HEARINGS OFFICER HEARING - LAND USE: HOMAN OUTDOOR MOTOCROSS TRACK

FILE NUMBERS: 247-22-000812-CU / 247-22-000813-SP

1. **File Nos. 247-22-000812-CU / 247-22-000813-SP:** The applicant requests conditional use and site plan approval for a recreation-oriented facility requiring large acreage. Specifically, the applicant proposes a commercial outdoor motocross track.

Figure 4 – Cline Falls Airpark Noise Impact Boundary (Pink) & Subject Property (Red)

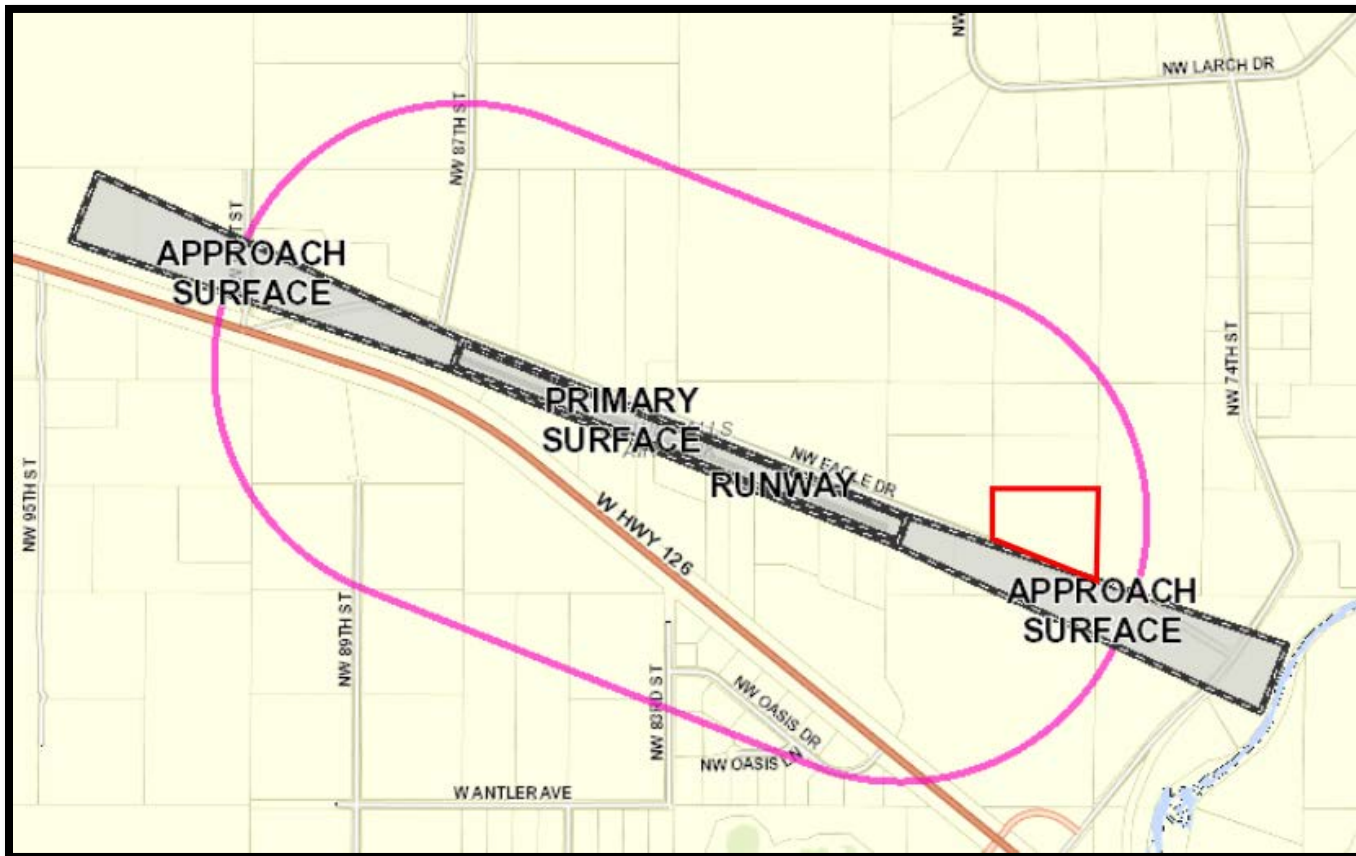
FINDING: The subject property is not located under any of the imaginary surfaces for the Cline Falls Airpark. However, the subject property is located within the Noise impact Boundary for the Cline Falls Airpark (see *Figure 4* below). Therefore, the provisions of this chapter apply.

Exhibit Site Plan

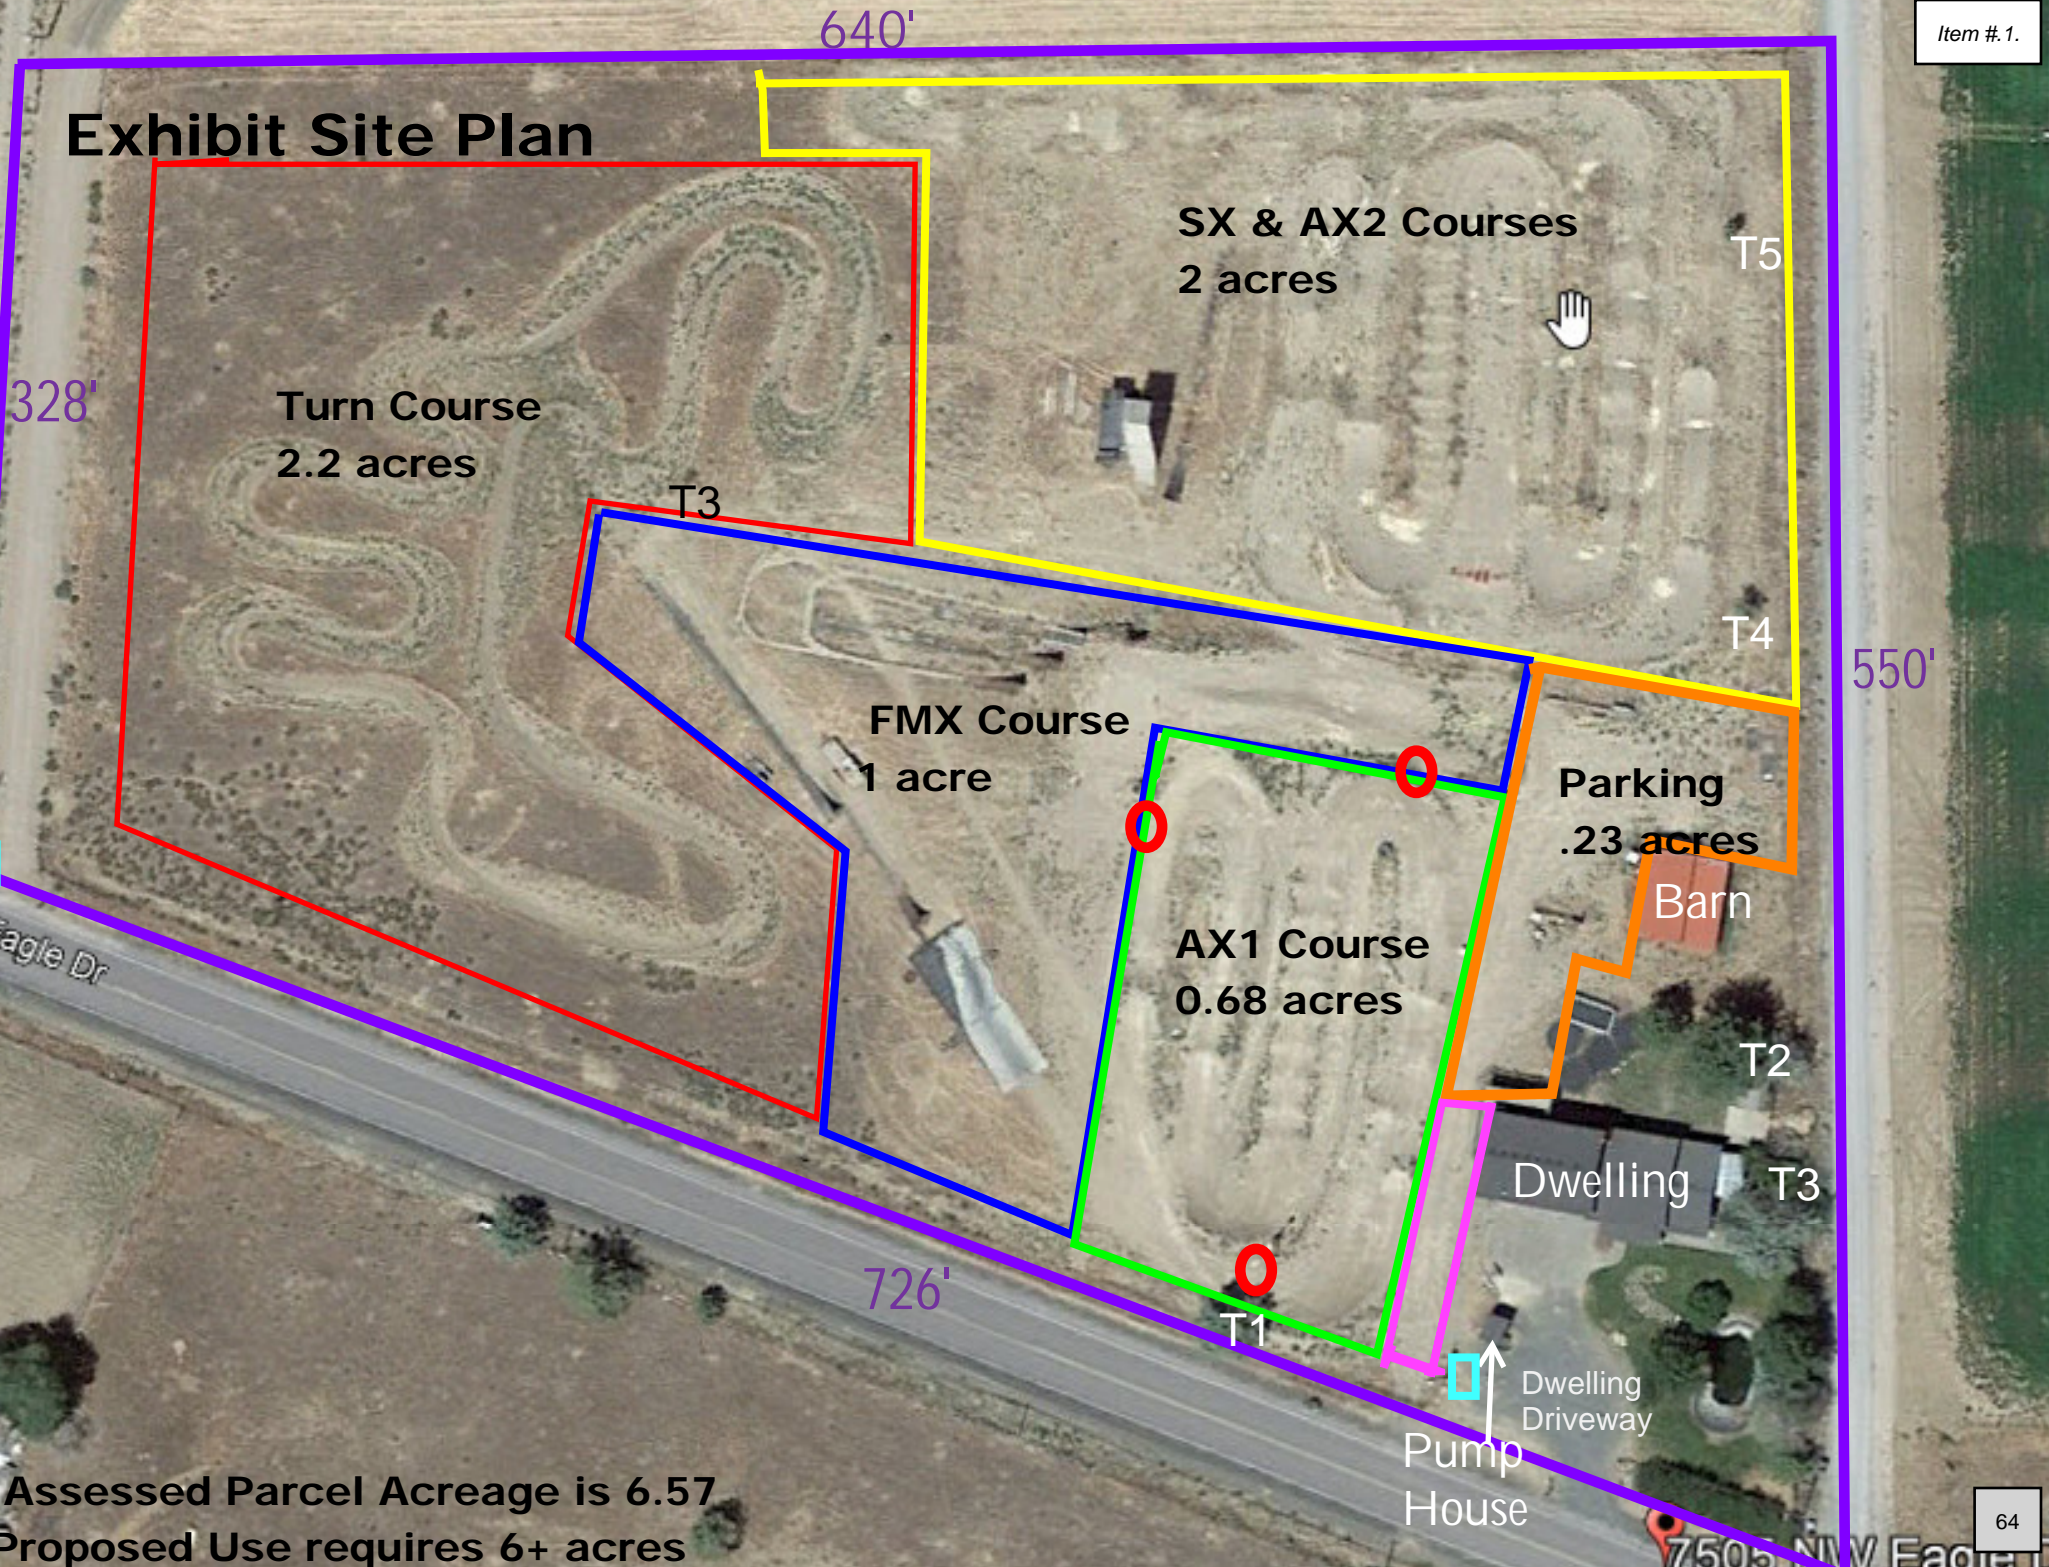
FINDING: The applicant proposes two-way access aisles, which requires a minimum width of 24 feet. The Applicant's site plan is not drawn to scale. Therefore, staff is not able to confirm the 24-foot aisle width will be met. Additionally, the areas identified for parking/access do not match on the various plans (see highlighted areas on Applicant's Exhibit Site Plan vs. Exhibit Site Plan Design). Staff asks the Hearings Officer to confirm if the Applicant has demonstrated compliance with this criterion.

However, as noted above, the site plan is not drawn to scale. For this reason, staff cannot confirm the minimum aisle widths are met. It is also unclear if or how pedestrian walkways have been integrated into the site plan. Typically, landscaping and walkways provide for a safe design for pedestrians on the site. However, these details are not included in the submitted materials or an explanation on why they are not required. For these reasons, it is not clear if the Applicant has demonstrated compliance with these criteria and staff asks the Hearings Officer to make specific findings on this issue.

FINDING: The applicant has not provided a drawn to scale site plan. For this reason, staff is not able to confirm the Applicant’s proposal complies with these criteria. The Applicant provided the following response on pg. 18 of the Burden of Proof Statement (Amended 3.23.2023):

FINDING: The Applicant’s Exhibit Site Plan Design (Traffic Flow) shows the northeastern portion of the participant-only parking area will be adjacent to a lot line. However, the site plan is not drawn to scale and staff could not identify any proposed landscaping in this area. Therefore, staff asks the Hearings Officer to determine if the Applicant had demonstrated compliance with this criterion.
